S.L. CHASSE STEEL – 201 & 199 ROBINSON ROAD

SITE PLAN APPLICATIONS #03-21 #04-21 & CUP #07-21

STAFF REPORT #3

Re: Town of Hudson Planning Board Review
SL Chasse Steel Site Plan, Robinson Road
Tax Map 105 Lot 17-2; Acct. #1350-532
Reference No. 20030249.2020

SIGHT DISTANCE PLAN
SCALE: 1" = 40'

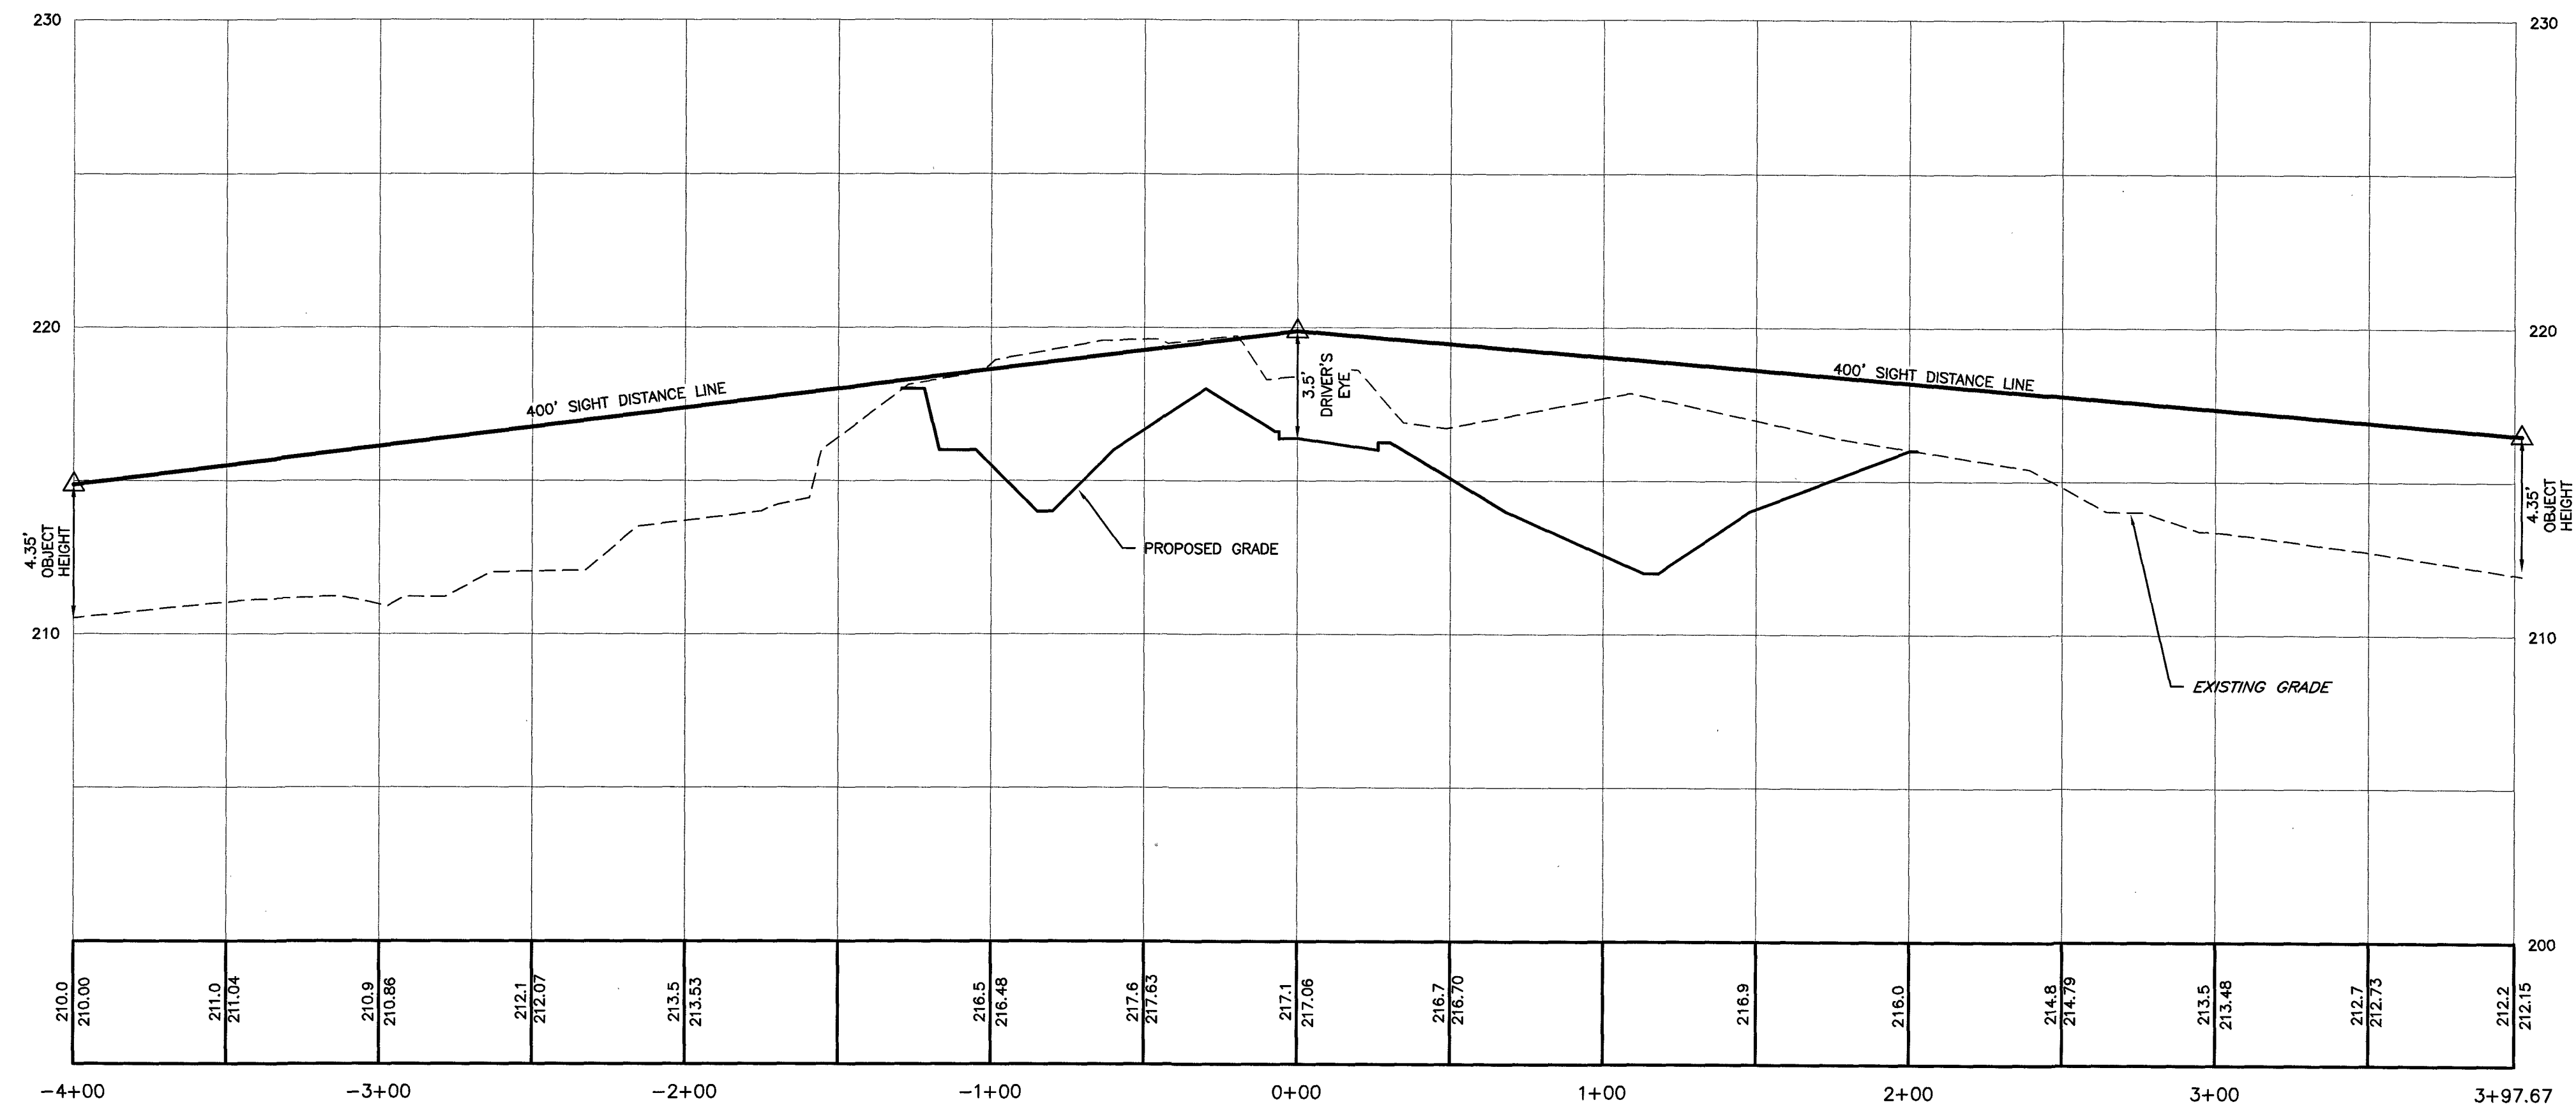
- a. **Former/Current Fuss & O'Neill Comment:** HR 193.10.E. The applicant has shown sight distances of 400 feet for the proposed driveway on the plan set. We note that the site line is very close to the existing grade at Station 1+00 and that it does not take into account snow or vegetation. The applicant should review the need to modify this area to better account for seasonal obstructions.

REVISIONS			
No.	DATE	DESCRIPTION	BY
1	05/12/21	TOWN COMMENTS	SCV
2	08/17/21	TOWN AND AOT COMMENTS	SCV
DATE: APRIL 6, 2021			
SCALE: AS SHOWN			
PROJECT NO: 20-0921-2			
SHEET 12 OF 16

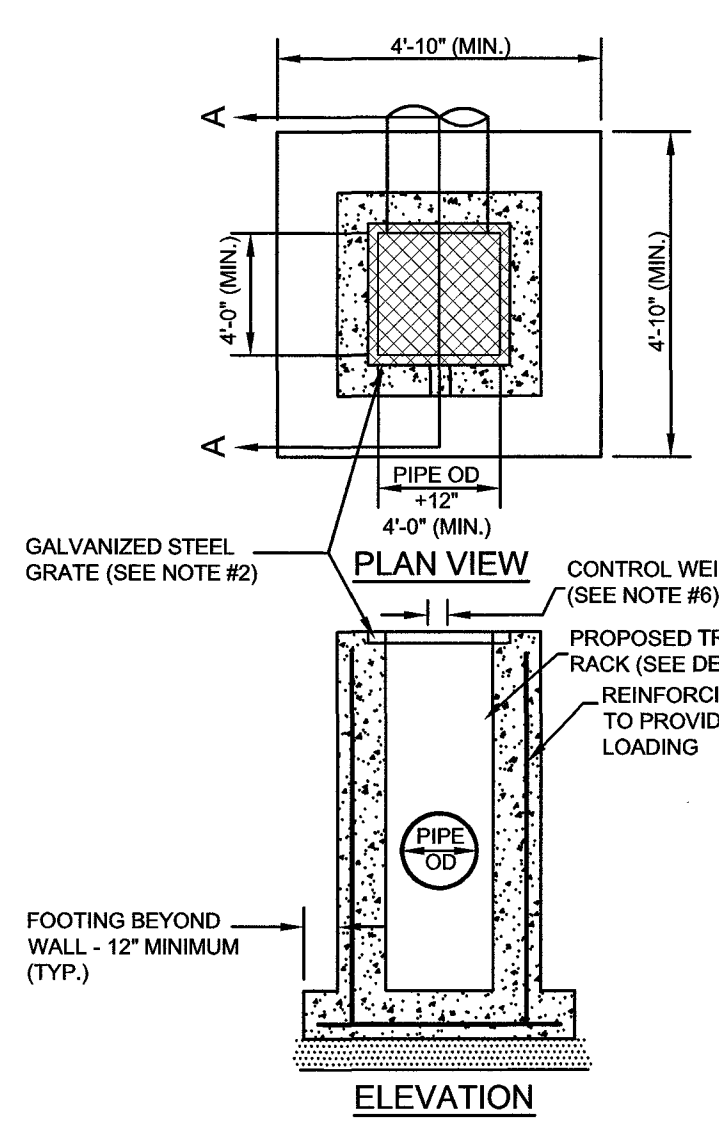
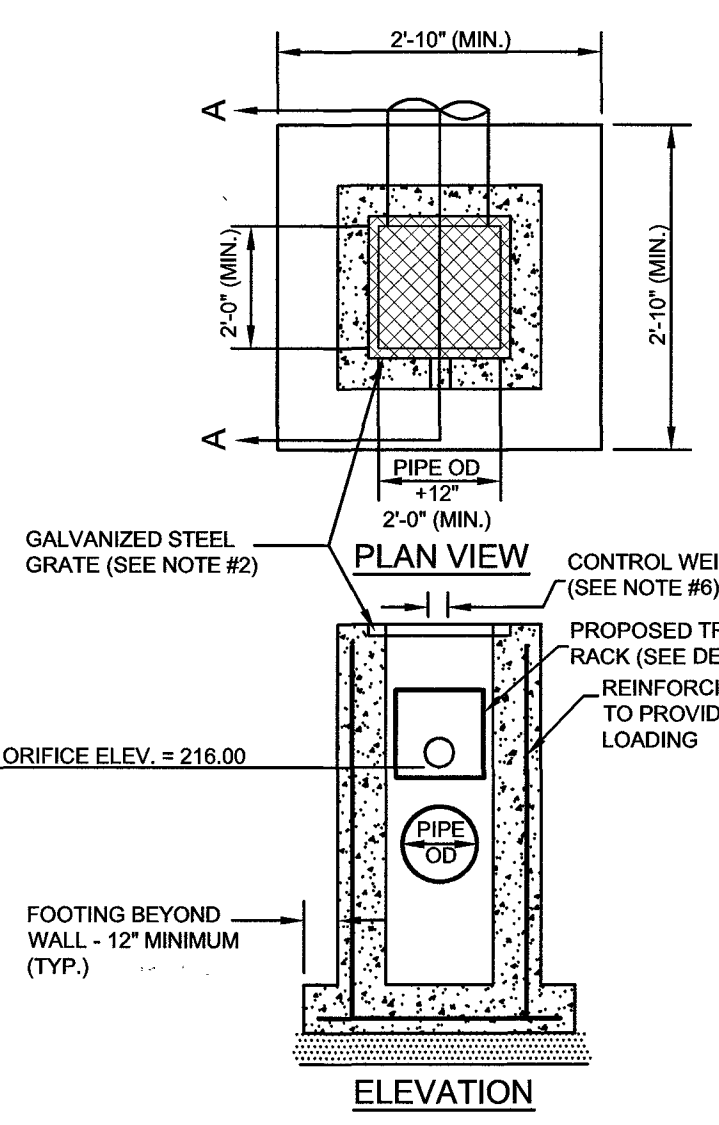
- d. *Former Fuss & O'Neill Comment: HR 290-5.A.(11). The Drainage Report calls for a 24"x24" horizontal top grate for both Infiltration Pond #2 and Detention Pond #2, while the details on Plan Sheet 12 (Lot 17-2 Set) calls for a 48"x48" top grate. The applicant should coordinate the details and the calculations.*

Current Fuss & O'Neill Comment: The applicant updated the details. No further Fuss & O'Neill comment.
